Re: Homestead Bay – Fast Track Application

250398Q-01 Homestead Bay Do Review .Docx

Appendix B: Proposed Land Treatment Areas

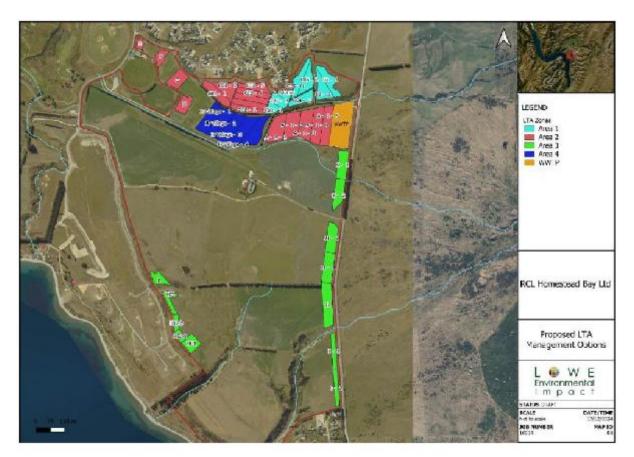
All wastewater will be collected and treated varier a new treatment plant to be located next
to the state highway. The orange area in the north east corner of the site on the image
below. Once water has gone thru the treatment plant it will be disposed of to ground,
generally to area along the north and east of the site. Shown as the various other coloured
areas on the image below.

Based on the design some of the risks that need to be considered are:-

• Operational Risk – If the treatment plant does not operate correctly then the contaminate levels will be higher than planned.

- Climate the use of vegetation uptake of nitrogen is relied upon, local winter growing
 conditions are poor and factored into the modelling to a certain base level. These will be
 subject to seasonal change and variability.
- Flow path short circuiting to ground water and/or lake Soil ground profiles have been mapped on a limited amount of bore holes and test pits and assumptions made that these reflect the overall ground profile. Variations in ground conditions could lead to short circuiting of flow paths.

That said there is ultimately the backup plan of routing the wastewater from the development to the main Queenstown Wastewater Treatment Plant at the Shotover River. Future proofing for this option needs to be considered early on in the layout of the subdivision reticulation. QLDC have asked for this to be done, but no information was supplied to indicated that has been actioned to date.

To mitigate against the risks summarised above it is proposed to have extensive downstream water quality monitoring requirements of both the existing streams and ground water at the lake fore shore.
